MILITARY SPECIFICATION

FUZE, PIBD, XM740, SECOND ENVIRONMENT SENSOR ELECTRONIC MODULE FOR

This amendment forms a part of Military Specification MIL-F-63231 (AR) dated 17 August 1979, and is approved for use by the U.S. Army Armament, Munitions and Chemical Command and is available for use by all Departments and Agencies of the Department of Defense.

Figure 1 - Direction of Applied Acceleration

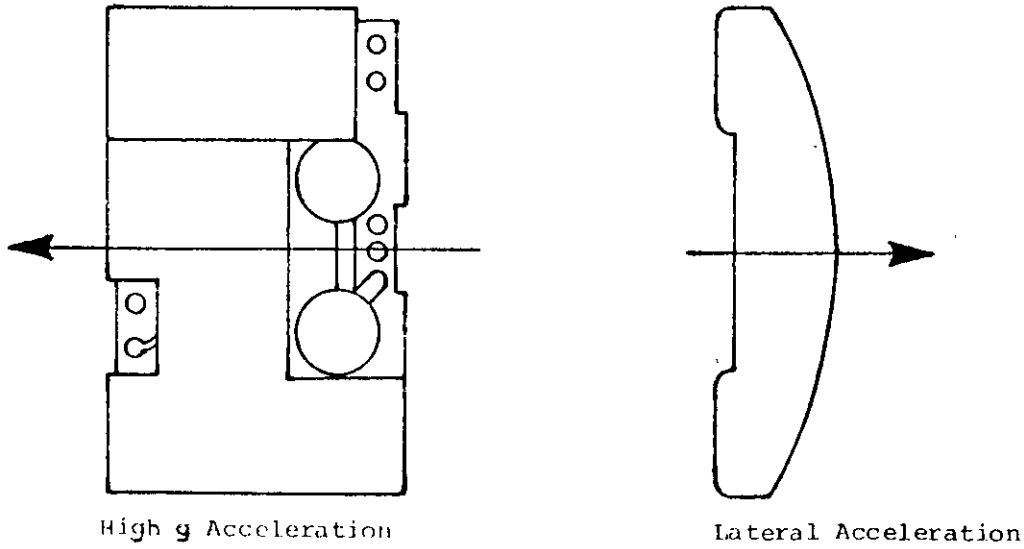
Figure 1: Delete and substitute the following:
